CITY OF CONWAY, ARKANSAS HISTORIC DISTRICT COMMISSION

HISTORIC DISTRICT COMMISSION

December 28, 2022

812 Davis Street - New Accessory Structure and Fence

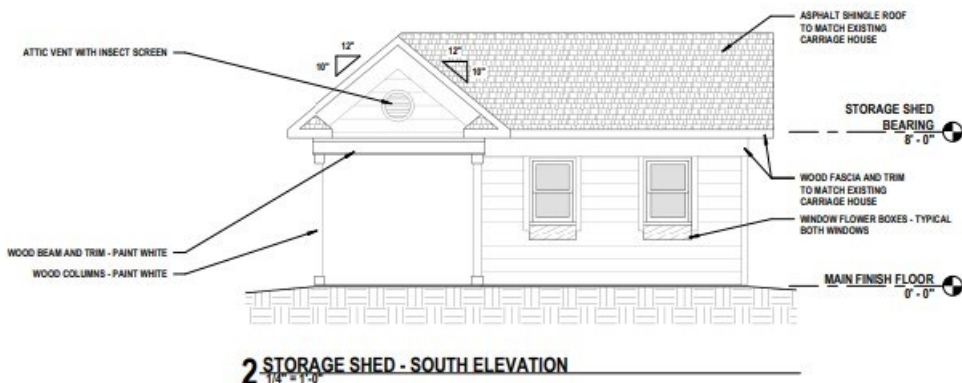
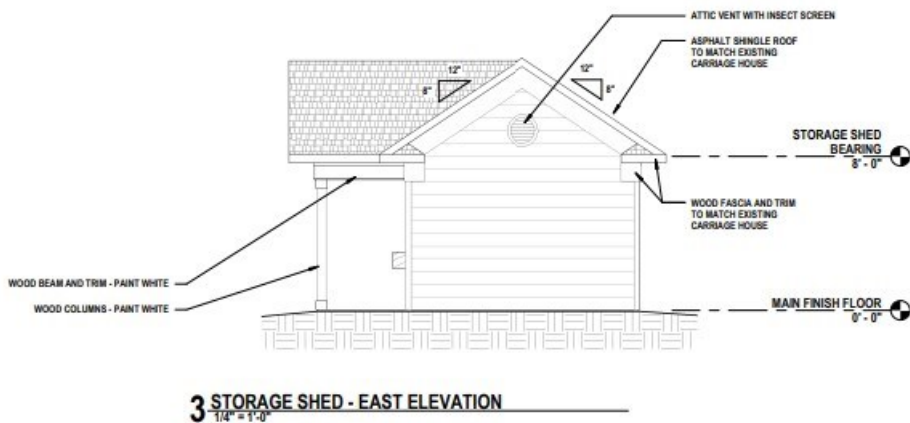
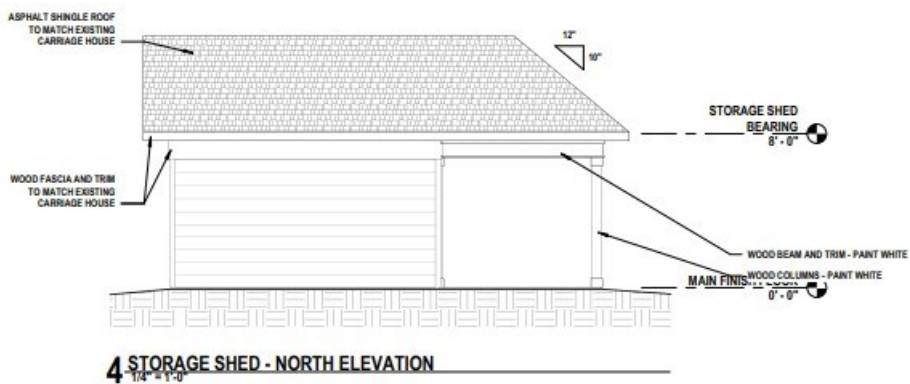
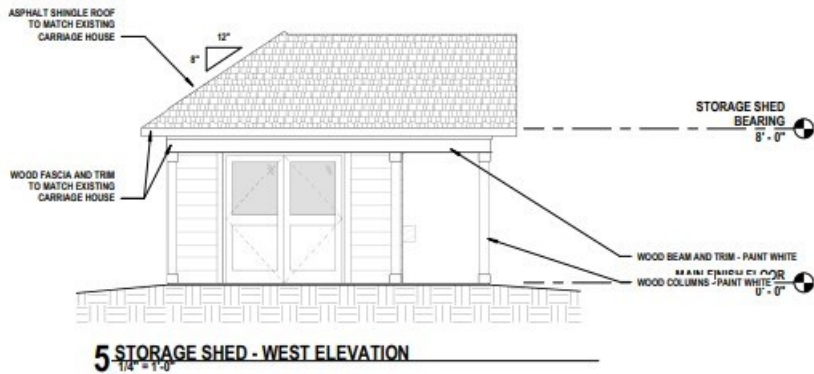
The applicant is proposing a 4' tall fence along the north, south, and west perimeters of the property. The applicant is proposing a 6' tall fence in the rear along the east property boundary, shared with the abutting parking lot. The applicant is proposing to use one of three fence styles: All ornamental metal, ornamental metal with brick columns, or a solid brick wall.

Given the age of the adjacent residence and character of the neighborhood, fencing of ornament metal, with or without brick piers, is appropriate. Approving the use of ornamental metal, with or without brick piers, not exceeding 6' in height is recommended for the side yards. Approving the use of ornamental metal, with or without brick piers, for the rear yard fencing with a height not to exceed 6' is recommended. Landscaping shall be used for additional buffer.

A solid brick wall, especially at a height of 6', is not appropriate. However, considering the nature of the abutting use to the east, a parking lot, it is recommended the applicant be allowed to utilize a solid brick wall, not to exceed 4' in height, in the rear for the east property boundary only, if desired. If a total height of 6' is desired, the applicant could utilize 2' of ornamental metal providing at least 50% opacity.

The proposed height of the front yard fence exceeds the maximum height allowed. Recommend reducing front yard fence to a maximum of 42" and require it be of ornamental metal with or without brick piers. Recommend approving the use of ornamental metal, with or without brick piers, for the rear yard fencing. As this portion of fence will connect to the side yard fence for the adjoining 1724 Robinson Ave property, the style and maximum height of the fence should be consistent and not exceed 42".

2. Wood or wood-like materials such as Hardie® siding should be used for all fascias and soffits.
3. A new fence to the side yards and rear yard of ornamental metal, with or without brick piers, not to exceed 6' in height is permissible. Alternately, a solid brick wall, not to exceed 4' in height, in rear along east property line only is also allowable. An additional 2' of ornamental metal with at least 50% opacity may be added to the top for a total height not to exceed 6'.

4. Front yard fencing, along Davis St frontage, to be of same style and height as adjoining 1724 Robinson Ave side yard fencing, not to exceed 42" in height. Approved materials are ornamental metal with or without brick piers.

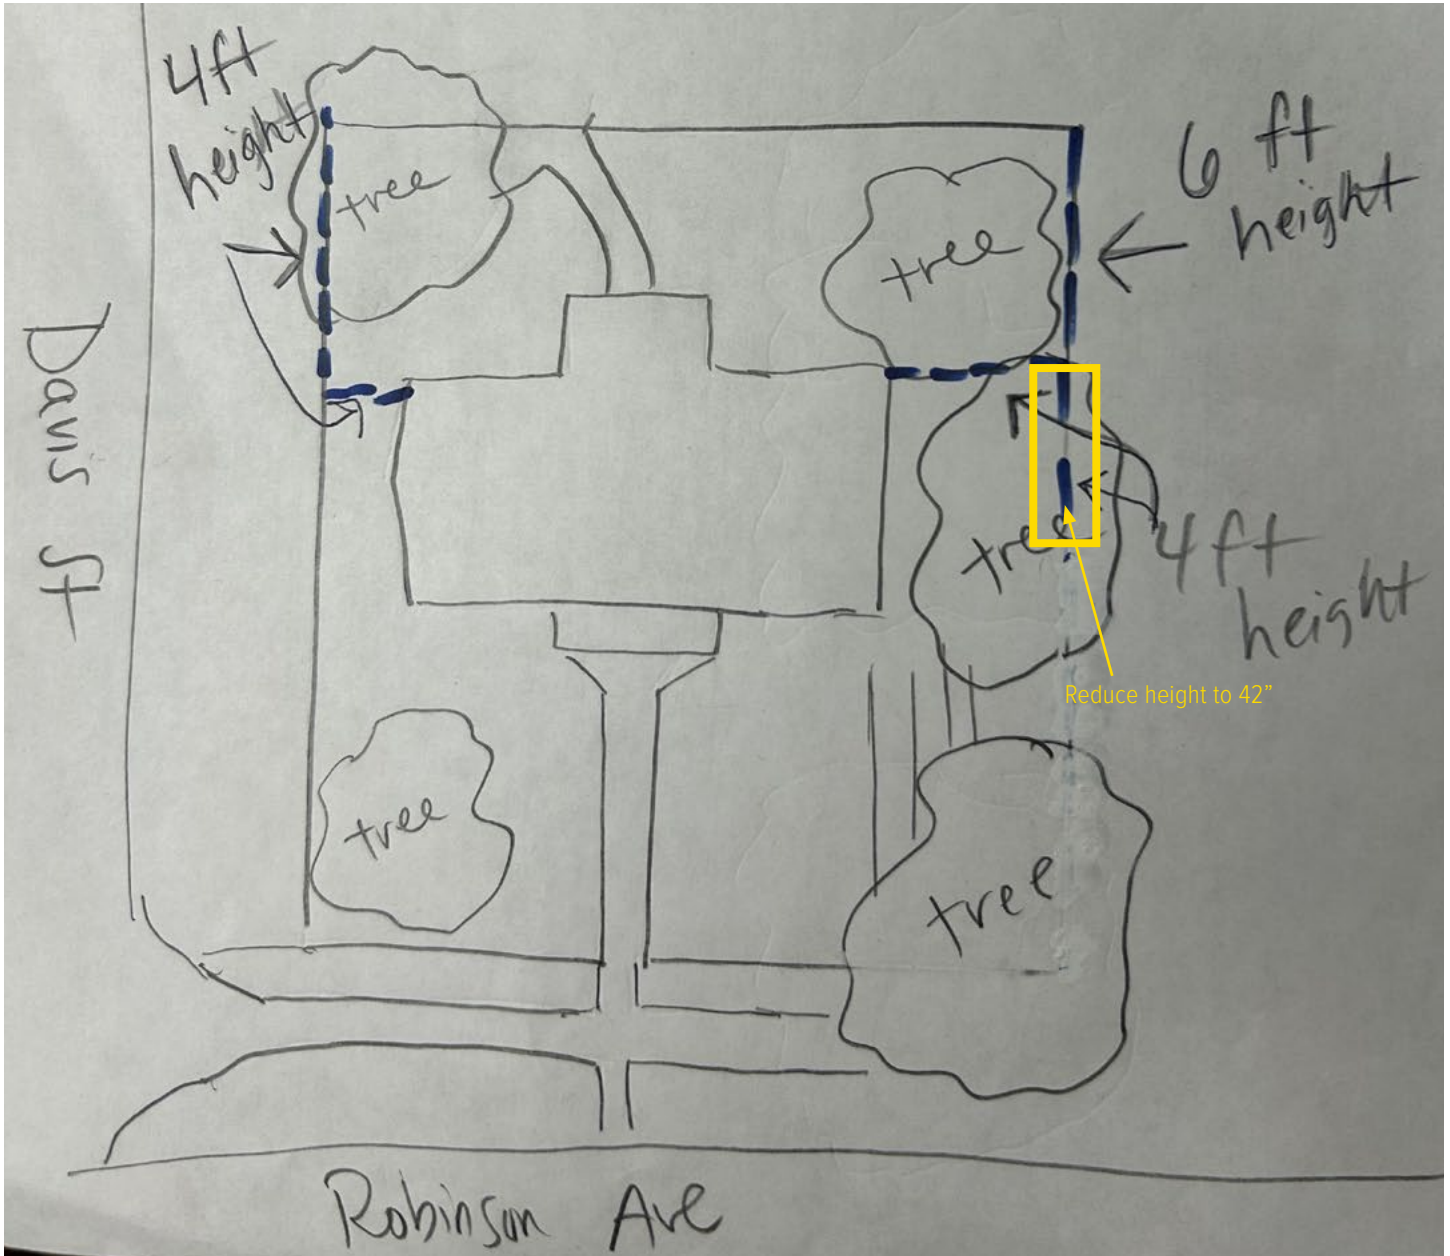
The applicant is proposing to replace the existing wooden fencing, which is not original, with a 4' tall fence along the Davis St frontage of the rear of the property, a 6' tall fence in the rear along the east property boundary, shared with the abutting parking lot, and a 4' tall fence in the front along the east property boundary shared with the abutting parking lot. The applicant is proposing to use one of 3 fence styles (pictured above), either all ornamental metal, ornamental metal with brick piers, or a solid brick wall.

Given the size, scale, and age of the residence, fencing of ornament metal, with or without brick piers, is appropriate. Recommend approving the use of ornamental metal, with or without brick piers, for the rear yard fencing. As the side yard fence along the Davis St frontage [for 1724 Robinson residence] will connect to the front fence for the adjoining 812 Davis St property, the style and maximum height of the fence should be consistent and not exceed 42". Rear yard fencing and side yard fencing [along the east property boundary] may be 6' in height.

A solid brick wall, especially at a height of 6', is not appropriate. However, considering the nature of the abutting use to the east, a parking lot, recommend allowing the applicant to utilize a solid brick wall, not to exceed 4' in height, in the rear for the east property boundary only, if desired. If a total height of 6' is desired, the applicant could utilize 2' of ornamental metal atop the brick, providing at least 50% opacity.

The proposed height of the front yard fence exceeds the maximum height allowed. Recommend reducing front yard fence to a maximum of 42" and require it be of ornamental metal without brick piers. If additional privacy is desired, the applicant could add additional vegetation at the base of the fence.

1. Allow a new fence in the rear and east side yard to be of ornamental metal, with or without brick piers, not to exceed 6' in height. Alternately, allow a solid brick wall, not to exceed 4' in height, in rear along east property line only. An additional 2' of ornamental metal with at least 50% opacity may be added to the top for a total height not to exceed 6'.
2. Side yard fencing along Davis St to be of same style and height as adjoining 812 Davis St front yard fencing, not to exceed 42". Approved materials are ornamental metal with or without brick piers.
3. Allow a new fence in the front yard, along the east property boundary, to be constructed of ornamental metal only [without brick piers] and not to exceed 42" in height. Landscaping to be used to provide additional screening if desired.

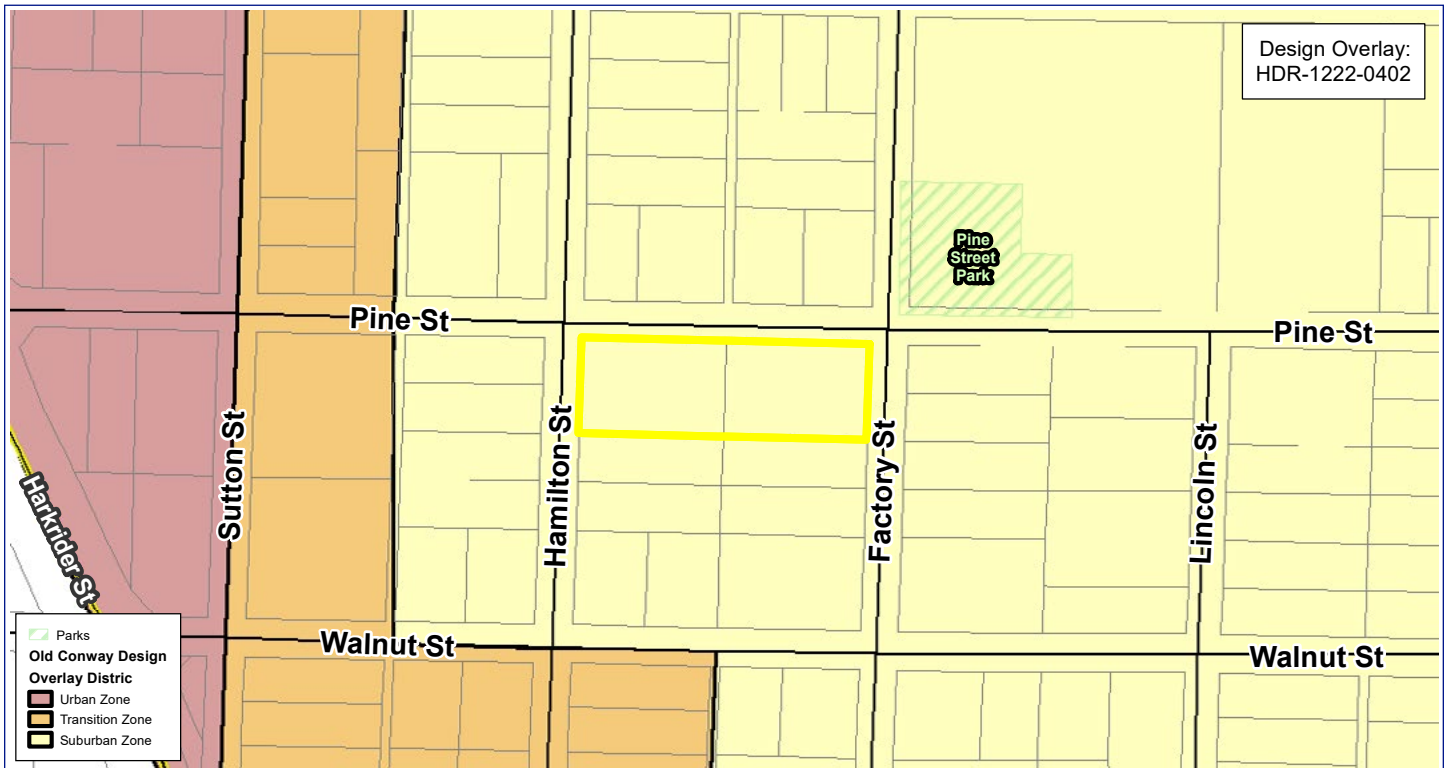
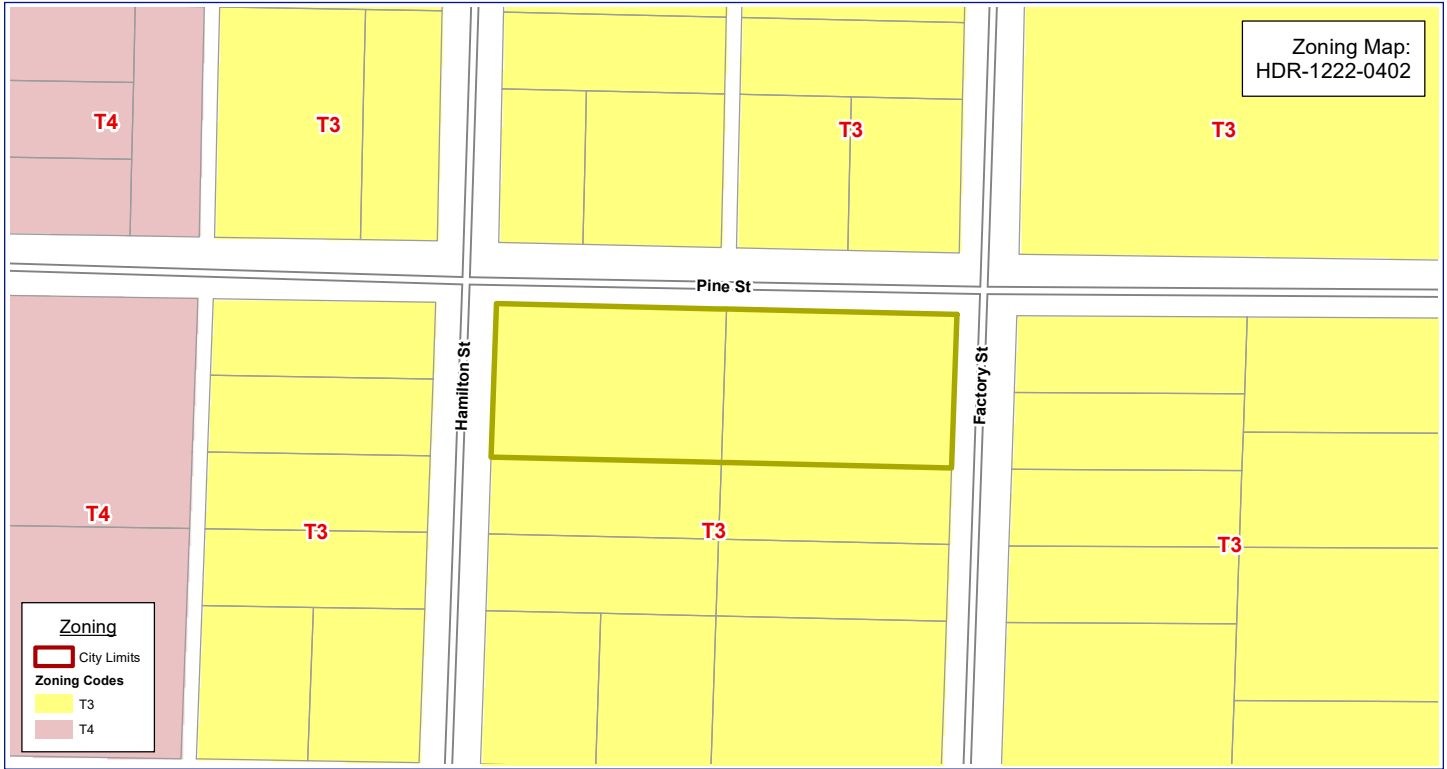
The structure meets required setbacks for the zone in which it is located and addresses the street. However, no entries face Pine or Factory Streets, as required by the design guidelines. Recommend requiring additional architectural detailing with an additional entry facing Pine St or Factory St.

The applicant is proposing use of brick and Hardie® siding across the structure. Detailing is appropriate to the structure if an additional public entry is added.

1. Require additional architectural detailing and a public entry along the Factory St or Pine St façade to signify the importance of the structure’s relationship to the street.
2. Defer review of landscaping requirements to the development review phase and require 1.25X normal landscaping requirements. A solid row of shrubs or low wall shall be required to screen the parking lot along all frontages.
3. HVAC/mechanical equipment be placed in a manner to minimize its visibility from the street.
4. Provide revised plans to the Planning Director for approval prior to issuance of the Certificate of Appropriateness.

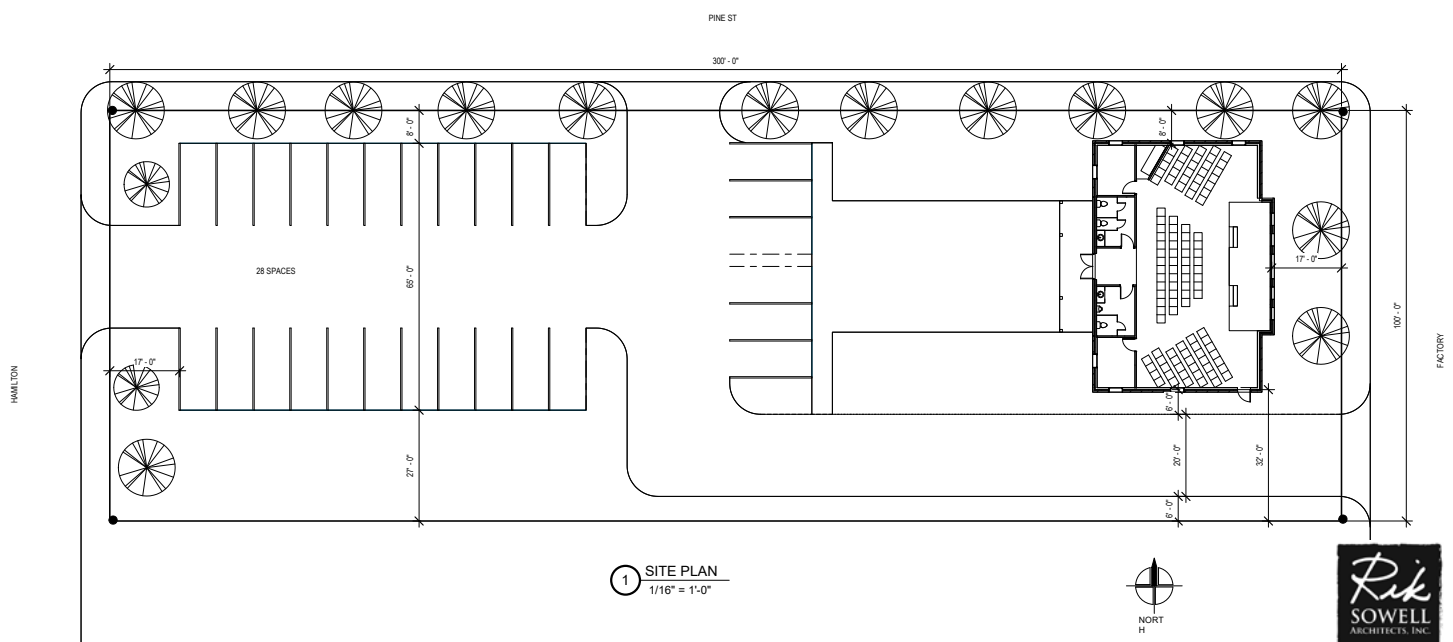
Recommend deferring setting landscaping requirement at the development review phase. Landscaping should be at least 1.25X required landscaping and include the planting of street trees along Hamilton St, Pine St, and Factory St.

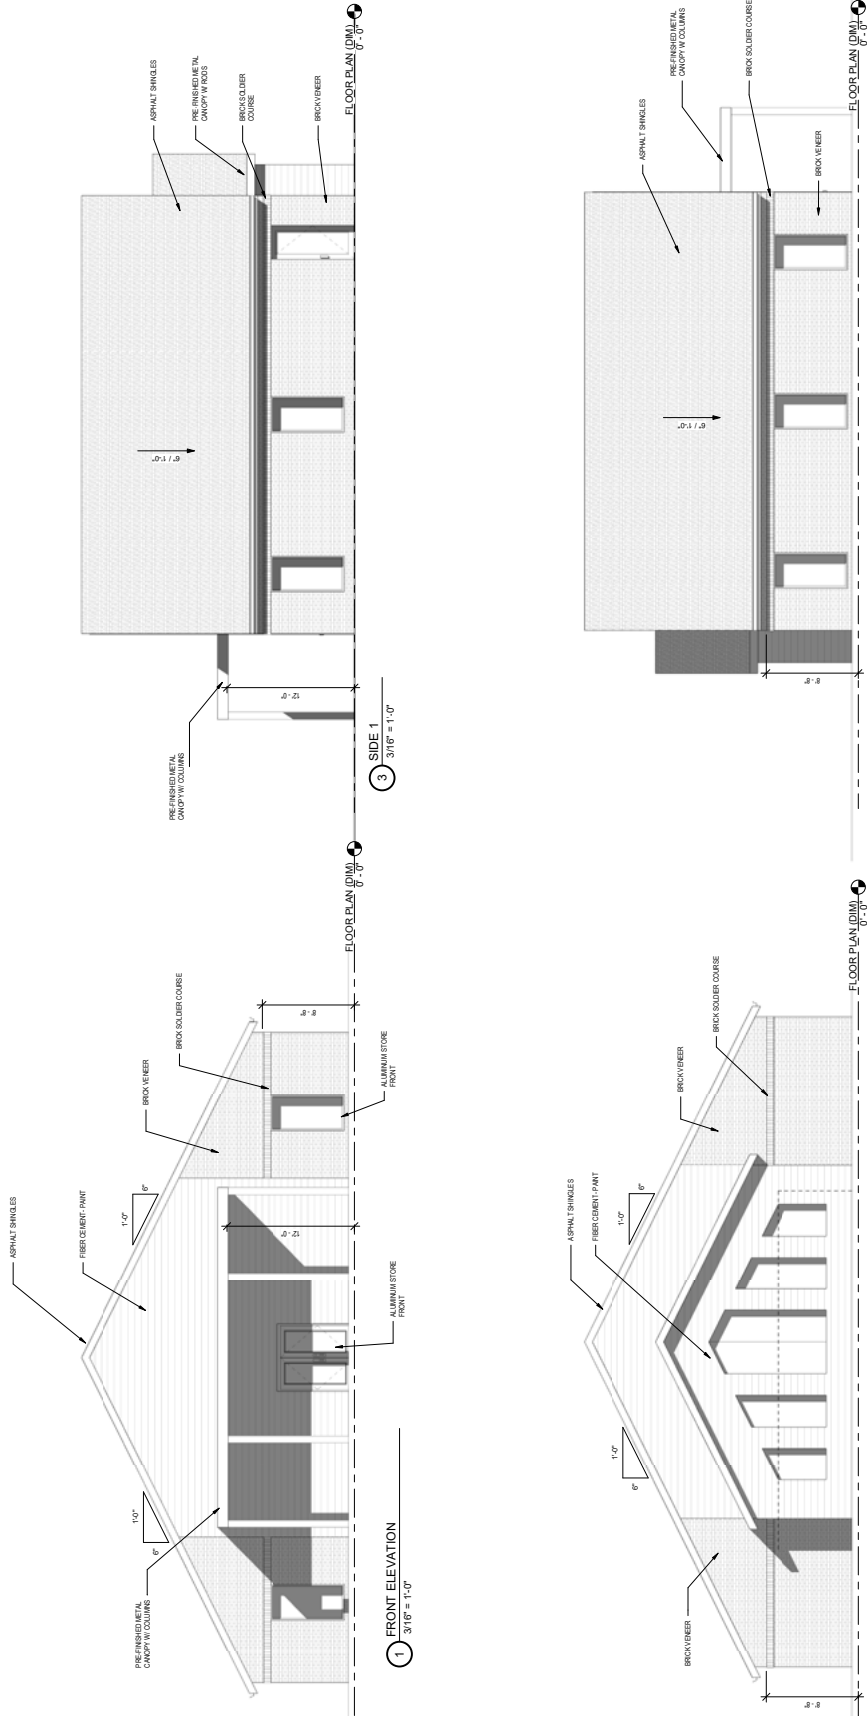
Proposed parking is appropriately located. Development review will require the placement of plantings to screen the parking lot from all frontages.
